PTPD REPORT NO. 83-R-02
AFPEA PROJECT NO. 82-P7-68

TEST AND EVALUATION OF METHOD II, GAU-8 30mm
AMMUNITION CONTAINERS

HQ AFALD/PTPD
AIR FORCE PACKAGING EVALUATION AGENCY
Wright-Patterson AFB OH 45433

August 1983

FIGURE 3. Original containers did not meet the 6 1/2 inch spacing requirement between forklift openings for the hand-lift-truck compatibility.

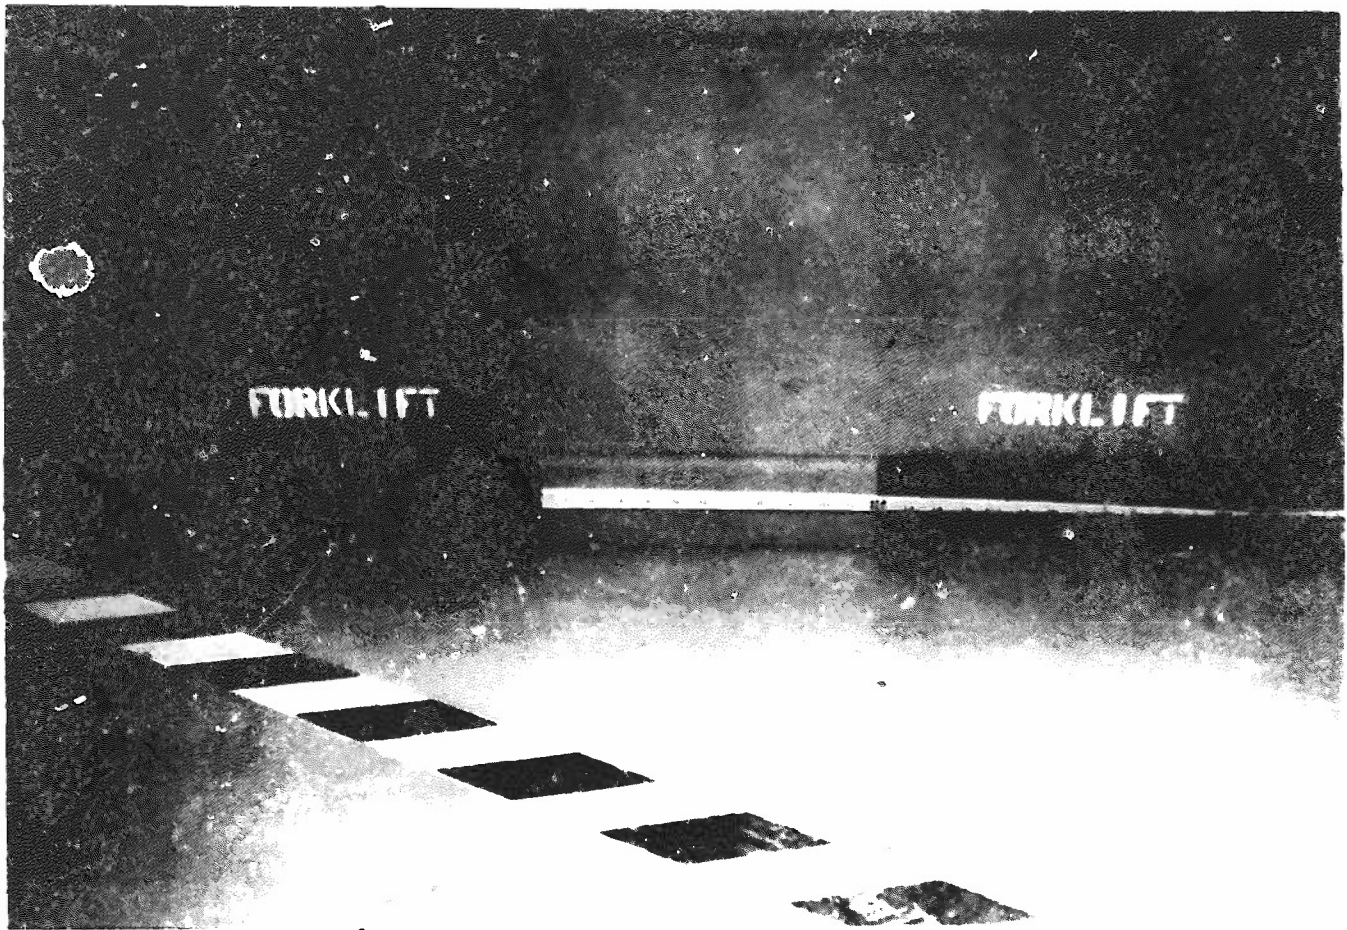
Six Method II, GAU-8 30mm ammunition containers were received on 23 Dec 82. Upon initial inspection, it was determined that these containers did not meet the specification requirements for hand-lift-truck compatibility, 8 1/2" between forklift openings (see Figure 3). They were returned to the manufacturer for modification on 4 Jan 83. The modification consisted of enlarging the forklift openings and strengthening the forkwell area. The modified containers were returned on 6 Jan 83. Containers S/N00005 and 00006 were selected as the test unit and were loaded with dummy ammunition (see Figures 4 & 5). The gross weight of the test unit was 2175 pounds. Testing began on 10 Jan 83 using the following sequence.

FIGURE 6. Modification made to the containers after failing first Pendulum-Impact Test. Note the steel gussets welded to the impact area of the containers.

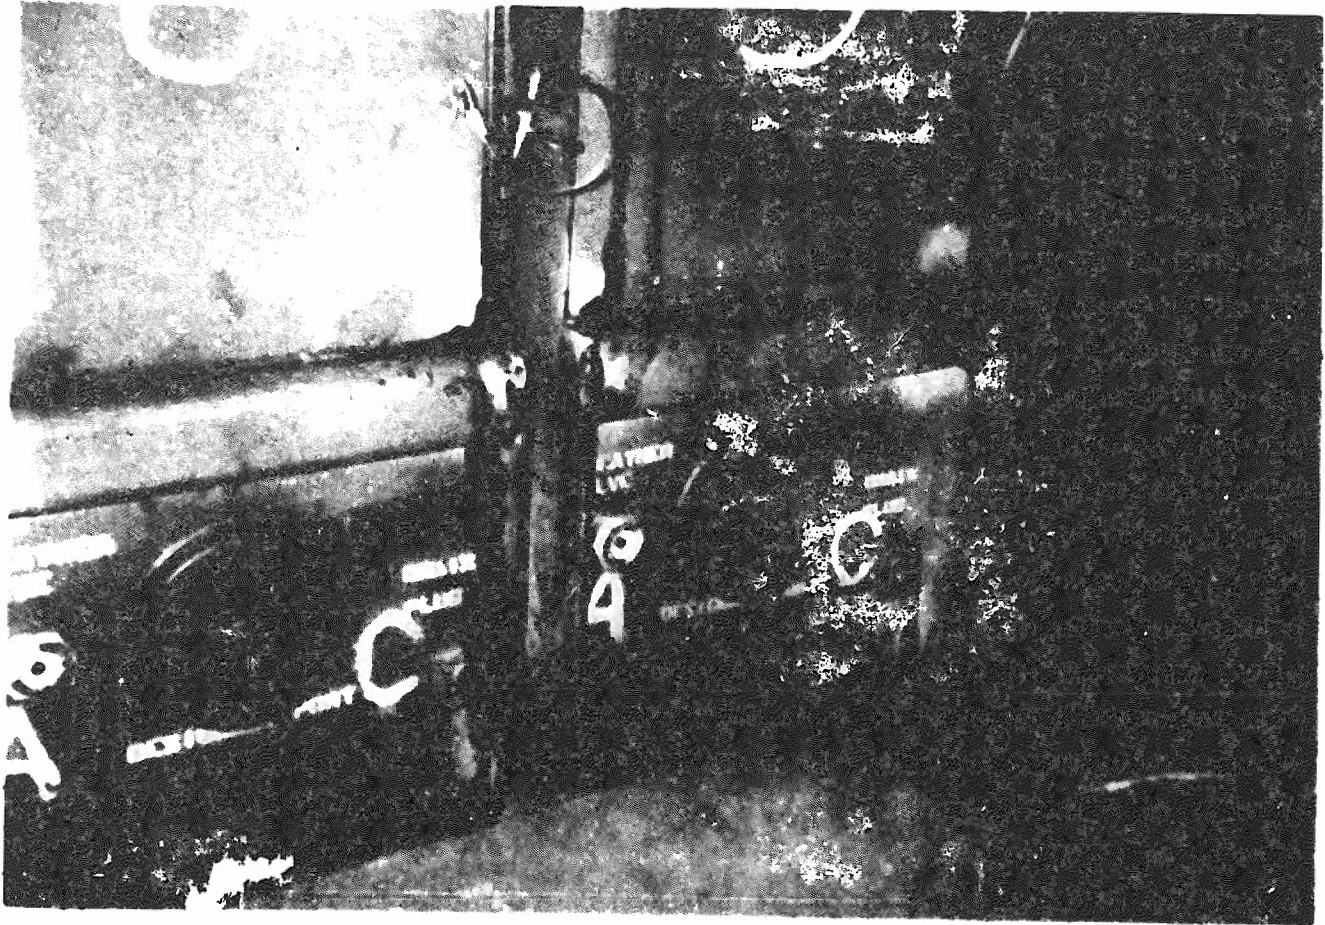
c. Comments: This test was performed out of the proposed test sequence at the manufacturer's request. Obvious deficiencies in the guard for the desiccant port cover and the breather valve existed. The manufacturer's representative had the necessary additional hardware to correct this problem with him but insisted on running the test prior to this modification. When the containers were impacted on the desiccant port ends, the desiccant port caps were crushed and would no longer seal. Also, on the final impact, which was to the broad side of one of the containers in the unit, small tears occurred in the sides of each container where the middle locking angle was welded. The locking pins were located in these middle locking angles. At this time, testing was terminated.

The containers comprising the test unit were disassembled, repaired and modified by welding two steel gussets to the containers as indicated in Figure 6. The same two containers were used again as the test unit except that their locking pin locations were changed to the top and bottom locking angles (see Figure 7). The relative position of each container was changed so that the same sides would not be impacted during the following tests. Testing was restarted on Tuesday, 11 Jan 83, and this time the initially proposed test sequence was followed:

FIGURE 15. Minor scuffing to Mylar-coating inside container from vibration testing.

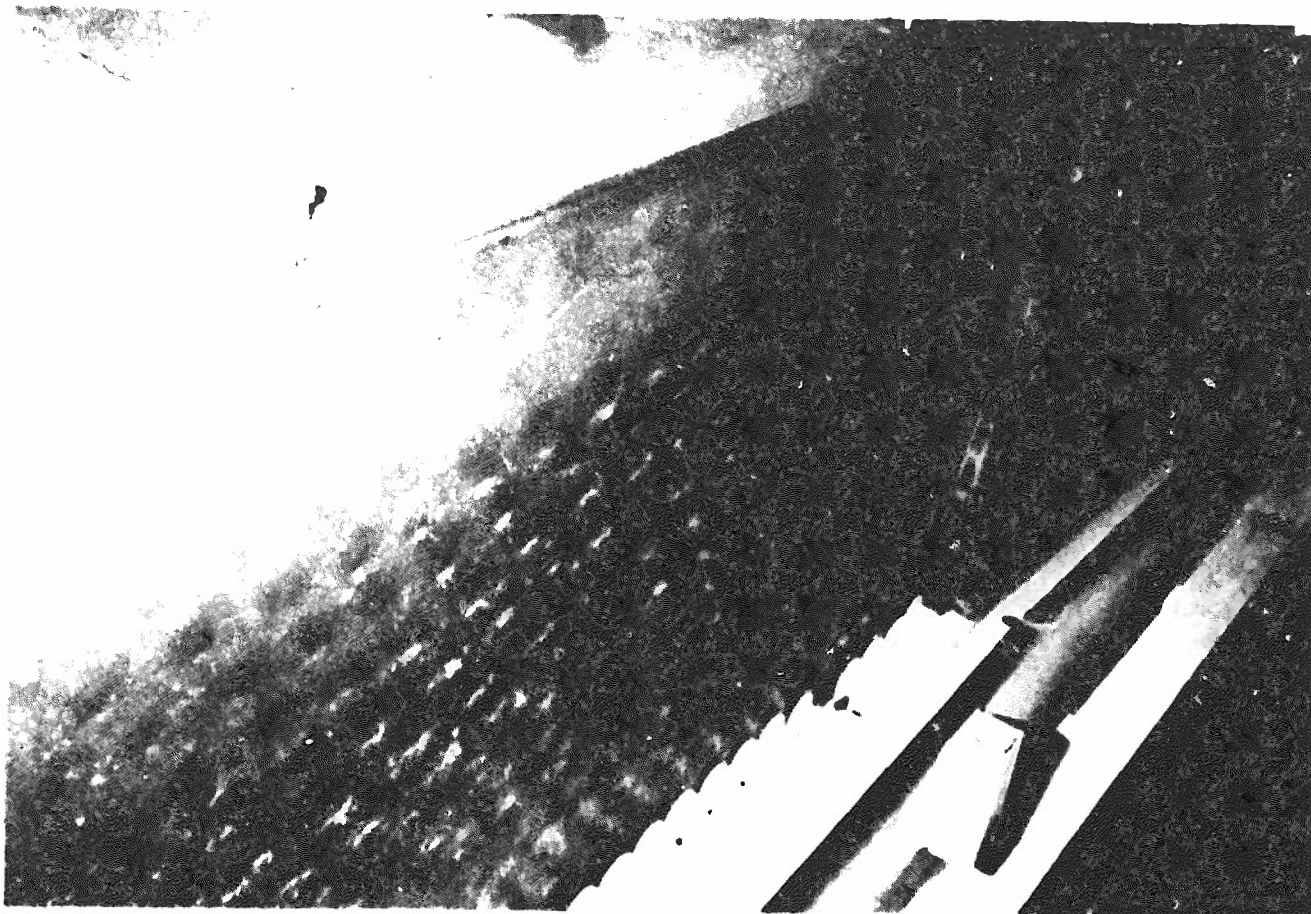
Following the final leak test, the containers were downloaded and the interiors inspected. With the exception of a narrow strip on the bottom of each container adjacent to the Mylar-coated side, no appreciable damage was noted (see Figure 15).

FIGURES 17 & 18. Damage to the containers from four foot free-fall-drop test IAW 49 CFR.

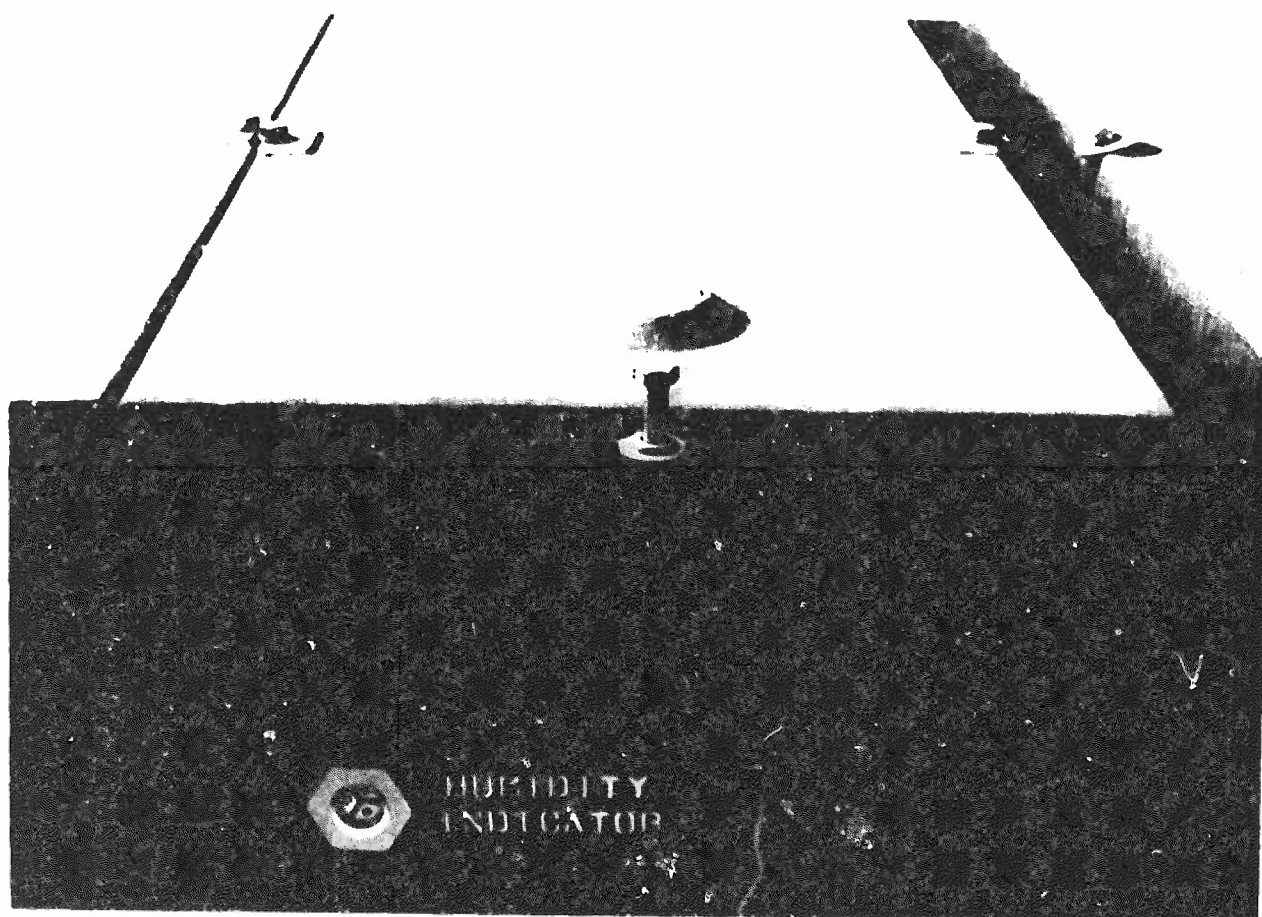
The most critical problem found concerns the width of the container lids. When two prototype containers are pinned together at the locking angles, their normal shipping and handling configuration, only one of the two lids can be correctly installed (see Figures 19 & 20). In order to install the second lid, the containers must be uncoupled and spread apart, a difficult operation since each container weighs approximately 1200 pounds.

The width of the container lids should be reduced by the previously prescribed 1/4 inch to insure adequate clearance between containers. This change should definitely be incorporated into the design prior to delivery.
